Appendix J Comments on the Draft EIS

SunZia Southwest TRANSMISSION PROJECT

Draft Environmental Impact Statement and Resource Management Plan Amendments (May 2012)

Figure 2. Habitat fragmentation in Arizona and New Mexico due to roads and transmission lines.

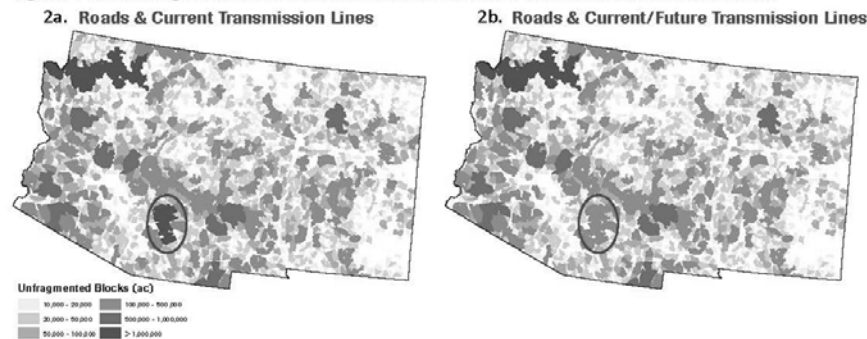
Figure 3 plots the distribution of habitat patch sizes in acres across Arizona and New Mexico. All patches smaller than 20,000 acres were excluded from the analysis to make the size of the graphic more manageable. Figure 3a illustrates how the current baseline condition is skewed considerably to the right, meaning the landscape of Arizona and New Mexico is comprised predominantly of small habitat fragments. This graphic also illustrates that outside of the Grand Canyon, there is no habitat block larger than the Galiuro-Aravaipa-Santa Teresa area. Figure 3b illustrates the change in ordinal position and size of the Galiuro-Aravaipa-Santa Teresa area from siting SunZia across the axis of this area.

However, transmission lines have not been demonstrated to fragment habitat to the degree of many other linear features. Arizona's Wildlife Linkage Assessment, an effort by ADOT, AZGFD, and Northern Arizona University to identify wildlife linkages in Arizona, focused for example on highways, major roads, canals, railways, border infrastructure, and urbanization as the major regional factors contributing to fragmentation. The assessment also noted that the effects of transmission lines and other sources of fragmentation may be considered at a later date.

No "major" fragmenters as considered in Arizona's Wildlife Linkage Assessment cross the Galiuro Mountains, and Subroute 4A or 4B of the Project would represent the most substantial infrastructure in that area. However, no evidence is available that indicates that the Project would prevent that habitat block from functioning as a whole. The DEIS acknowledges that standard and selective mitigation measures for design and construction would be implemented in this area, to minimize the amount of new access that would be created, to minimize the risk of erosion on steep slopes, and to avoid disturbance of wildlife during construction and maintenance.

Figure 5.

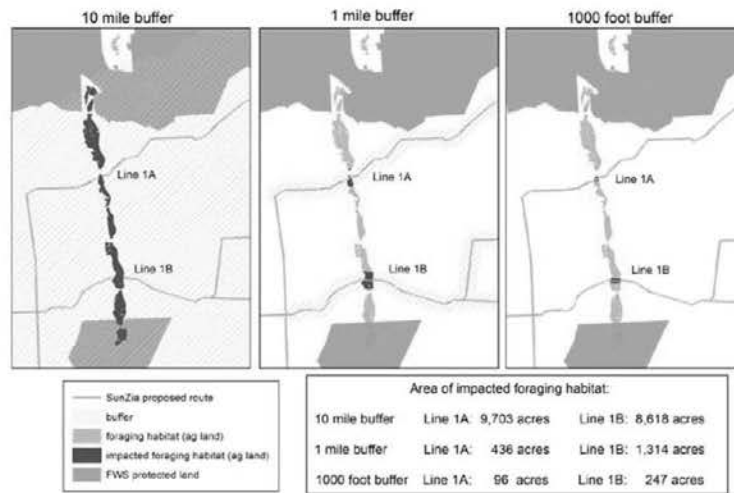
<p data-bbox="94 797 128 824">31</p> <p data-bbox="222 899 957 1104">We evaluated foraging habitat potentially impacted by the proposed alternatives. Figure 5 summarizes the acreage of foraging habitat within three different buffer distances from the proposed transmission lines, to estimate both indirect and direct losses. The largest buffer distance is 10 miles and is based on a study by Lewis (1976) which found that optimal roosting sites are located within 10 miles of feeding areas. The second buffer distance of 1 mile is based on the current U.S. Fish and Wildlife Service best management practices (BMP) for minimizing whooping cranes impacts. This BMP recommends that diverters be placed on all transmission within 1 mile of roosting sites. A 1,000-foot buffer was also evaluated to show the direct losses expected from conversion of foraging habitat within the construction corridor.</p> <p data-bbox="94 1195 128 1222">32</p> <p data-bbox="163 1130 953 1263">Although the conclusion of the Analysis of Potential Avian Collisions with Transmission Lines at Four Locations on the Rio Grande in New Mexico (EPG Study; SunZia DEIS Appendix B2) is that the construction of the SunZia project “would have no significant effects on the population status of any species living in or migrating through the Rio Grande Valley,” TNC believes that collision fatalities and the resulting population effects on sandhill cranes are difficult to predict accurately and EPG’s conclusion is not supported by its study for the following reasons:</p> <p data-bbox="195 1291 953 1359">1) The survey periods are incomplete and do not contain the entire migration cycle. The year one survey, December 2009 – March 2010, excludes much of the fall migration. The year two survey, August 2010 – December 2010, misses the late winter and spring migrations. The EPG</p> <p data-bbox="163 1385 325 1401">The Nature Conservancy</p> <p data-bbox="474 1385 663 1401">SunZia Draft EIS Comments</p> <p data-bbox="951 1385 972 1401">15</p>	32	<p data-bbox="1050 792 1083 820">32</p> <p data-bbox="1131 792 2045 808">The avian collision risk study, Appendix B-2 of the DEIS, was conducted independently by the University of New Mexico. EPG prepared the report for inclusion as an appendix of the DEIS. Although the mortality estimates in the study focused on construction of the Project with and without bird diverters, all available measures remain under consideration. The Avian Protection Plan will provide site-specific detail on the final selection of mitigation measures, and monitoring to assess the effectiveness of mitigation. Updated guidelines on reducing collision risk for birds will be released by APLIC in 2012, and this information will guide development of the Avian Protection Plan. All available measures will be considered and applied as appropriate to ensure compliance with the Migratory Bird Treaty Act.</p>
